ARKANSAS NUCLEAR ONE, UNIT NO. 2

AMENDMENT TO FACILITY OPERATING LICENSE

Amendment No. 169
License No. NPF-6

ATTACHMENT TO LICENSE AMENDMENT NO. 169

CONTROL ELEMENT ASSEMBLIES

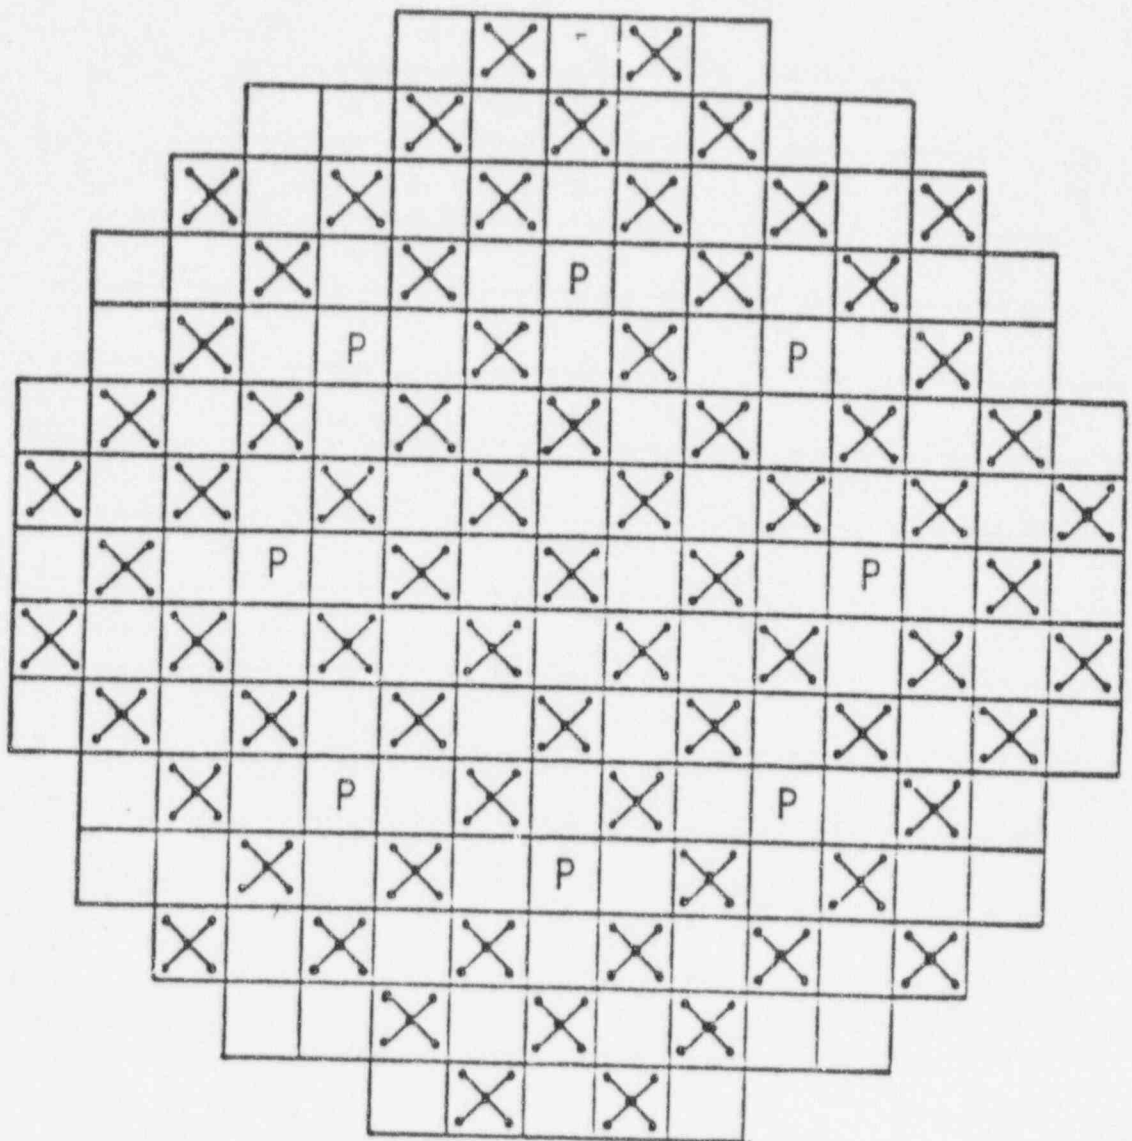
5.3.2 The reactor core shall contain 81 control element assemblies.
